ADS-B MASPS (DO-242A Draft) COMMENTS
RTCA SC-186

ISSUE:

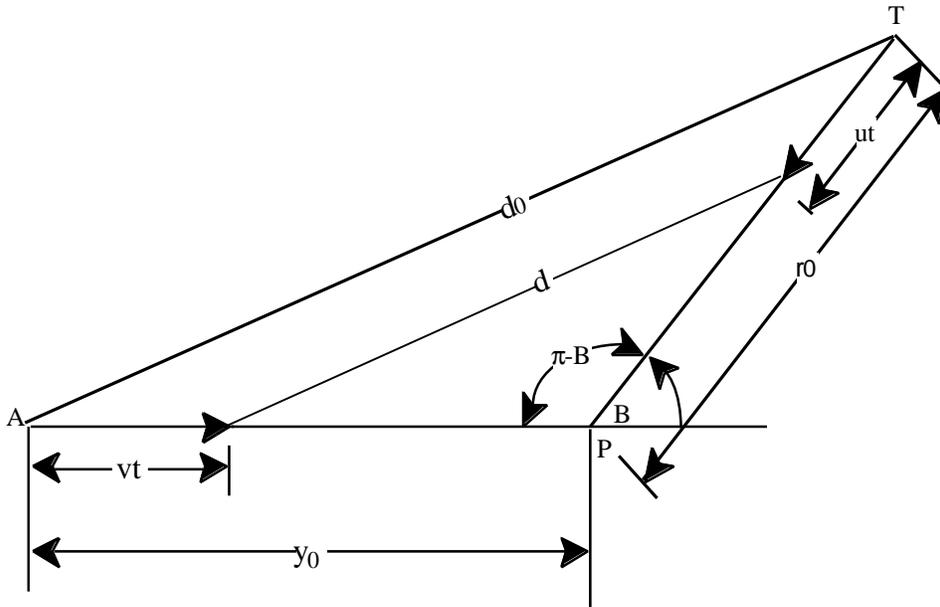
The ballot draft DO-242A has modified the air-to-air range requirement for the flight path deconfliction application in Note 3 to Table 3-4(a) to:

The 90 NM range requirement applies in the forward direction. The required range aft is 40 NM. The required range 90 degrees to port and starboard is 64 NM. (see Appendix H) [The 120 NM desired range applies in the forward direction. The desired range aft is 48 NM. The desired range 90 degrees to port and starboard is 85 NM.]

The revised Note 3 for Table 3-4(a) incorrectly interprets the range requirement from Appendix H. Rather the 64 NM range requirement applies to targets at +/- 45 degree from forward and not from port or starboard (i.e., +/- 90 degrees from forward) bearing angles. Furthermore, there is no basis presented in Appendix H to justify the increase in aft range to the 48 NM value in the new Note 3 to table 3-4(a).

The intent of expressing the range requirements relative to target bearing is to provide a constant 4.5 minute acquisition range for encounters where the target aircraft is approaching from various bearing angles. The maximum aircraft velocity is set at 600 knots (Appendix H) thus the maximum distance either own aircraft or target aircraft can travel in 4.5 minutes is 45 NM. This leads to the 90 NM requirement from Table 3-4a being applicable to a head-on encounter.

Correct Draft DO-242A to the range values as specified in DO-242 as there is no justification for the proposed changes nor are the proposed changes of Table 3-4a, Note 3 consistent with the analysis of Appendix H (neither the original Appendix H or DO-242 nor the proposed revised Appendix H of DO-242A).

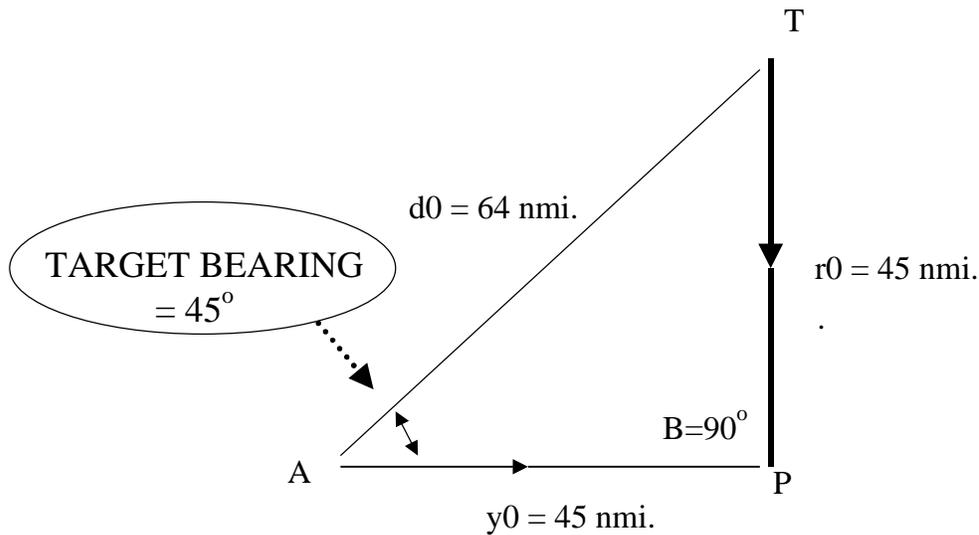
The specific text and the associated Figure from Appendix H that relates to Note 3 of Table 3-4a is from DO-242A Section H.2 (Constant Alert Time Analysis) and is provided below:

Several criteria may be used to examine air-to-air receive coverage requirements when all aircraft transmit with the same omnidirectional gain, G_0 . Figure H-1 shows own aircraft, A, headed along the y-axis at a speed, v , with a potential threat aircraft, T, moving at a speed, u , on a radial track intercepting the A projected track at y_0 at an angle, B. The separation between aircraft as a function of time is d . Figure H-1 also summarizes the relationships defining d and $\Delta d/\Delta t$, the rate of change of this separation range.

For a Level A3 ADS-B system, the required acquisition range for an encounter geometry with a minimum alert time requirement of 4.5 minutes (Table 2-3) depends on the encounter angle B as shown in Figure H-1. The worst case geometry is a head-on encounter with $B=0^\circ$ and both aircraft traveling at 600 kts, i.e. $u = v = 600$ kts. In this case the closure rate $\Delta d/\Delta t$ is 20 NM/min and the acquisition range in the forward direction is $R = 20 \text{ NM/min} * 4.5 \text{ min} = 90 \text{ NM}$. **For a crossing encounter with $B=90^\circ$ and both aircraft traveling 600 kts we have $d / \dot{d} = y = r$ and the closure rate is $Dd/Dt = 10 * \sqrt{2} \sim 14.14 \text{ NM/min}$. The acquisition range for this geometry is thus $R = 14.14 \text{ NM/min} * 4.5 \text{ min} \sim 64 \text{ NM}$. In the rear direction $B= 180^\circ$, the worst case geometry for an overtake is assumed to be the aircraft behind traveling at 600 kts and the lead aircraft traveling at about 120 kts for an aft encounter with a closure rate $Dd/Dt = 8 \text{ NM/min}$. In this case the acquisition range for an alert time of 4.5 minutes is $R = 8 \text{ NM/min} * 4.5 \text{ min} = 36 \text{ NM}$.** However, since a Level A3 system is also an A2 system with a minimum acquisition range of 40 NM in all directions (Table 2-3), the minimum acquisition range aft for an A3 is also 40 NM.

With angle $B=90$ degree for the crossing encounter this figure can be more accurately redrawn as follows:

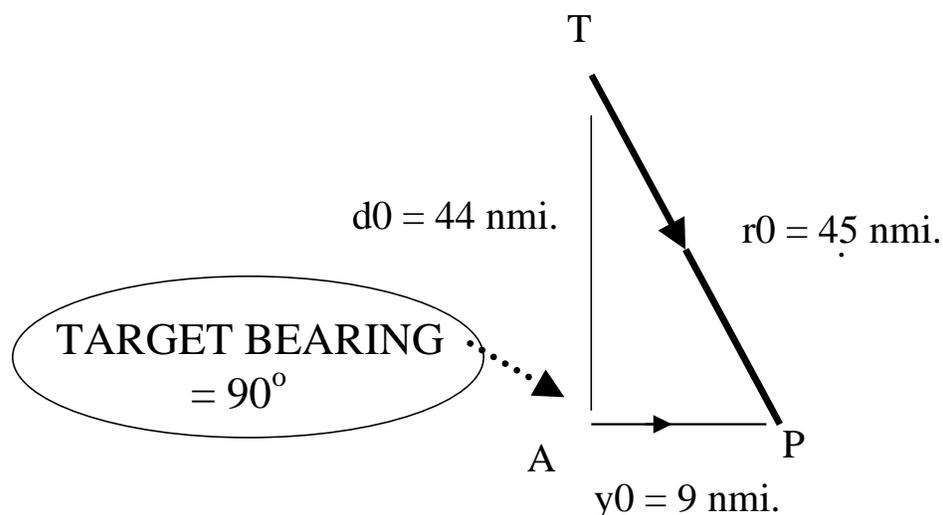
Thus the 64 NM range requirement is not appropriate for a Port or Starboard target bearing encounter but rather for an encounter where the target aircraft is approaching at a bearing of 45 degrees from the forward direction.

The worst case for a true port or starboard target bearing encounter and where own aircraft is operating at the minimum velocity and where the target aircraft is approaching at the maximum velocity (i.e., 600 knots). The current DO-242 Appendix H analysis used a minimum aircraft velocity of 300 knots in keeping with high altitude enroute/oceanic operations. The revised Appendix H of DO-242A has changed the minimum aircraft velocity to just 120 knots. While this low a velocity may be unrealistic for high altitude operations, even such a low value would result in the following maximum port and starboard air-to-air range requirement.

Thus in this worst case Port or Starboard encounter (requiring maximum air-to-air acquisition range) own aircraft (A) has a velocity of 120 knots and the target aircraft (T) has a velocity of 600 knots, the required range is 44 nmi. in order to provide target tracking for 4.5 minutes before point of closest approach.

Finally for the aft range the current DO-242 Appendix H describes a case where own aircraft is operating at 300 knots and is being overtaken by a target aircraft operating at 600 knots (maximum velocity). This would result in an aft range requirement of 22.5 NM for a 4.5 minute time to point of closest approach. The proposed DO-242A appendix H decreases own aircraft velocity 120 knots and this results in a revised requirement for a 36 NM aft range in order to provide a 4.5 minute time to point of closest approach. There is no justification provided for the Table 3-4a, Note 3 aft range requirement of 48 NM nor is there any justification provided for reducing the minimum aircraft velocity from 300 knots (of DO-242 Appendix H) to the much lower value of 120 knots as included in DO-242A Appendix H.
